TE Connectivity

Product Change Notification: PCN-26-278388

18POS,TAB1.5X0.64,HDR ASSY,90DEG

Sheet 1 Before change

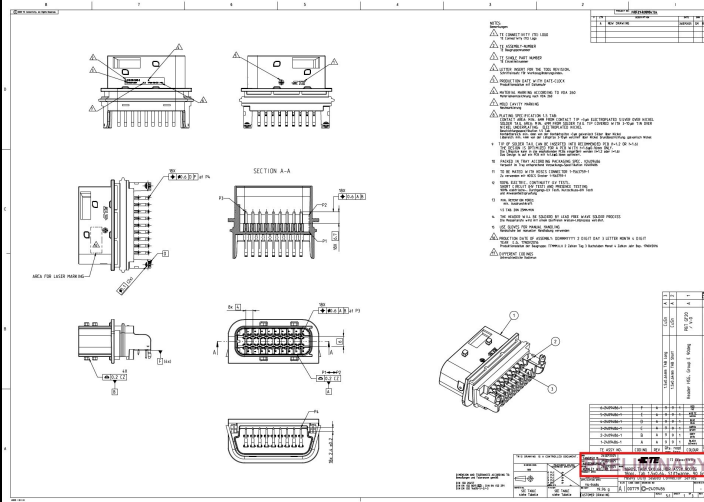
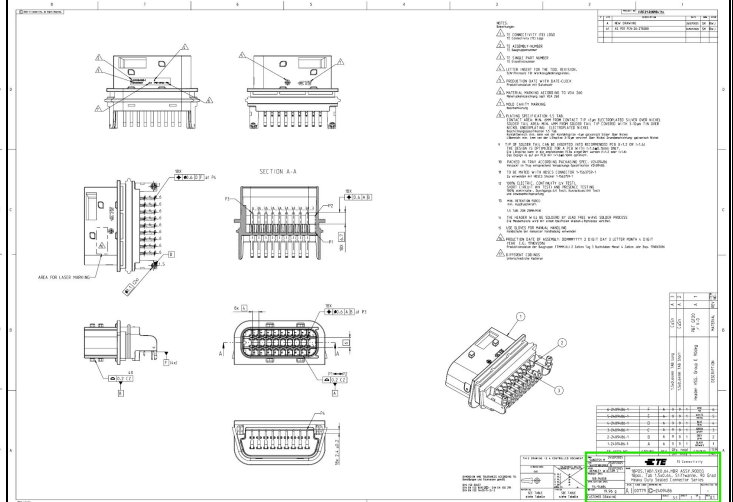
Sheet 1- preliminary water mark stamp removed. Sheet 3 - PCB Print pin numbering corrected.
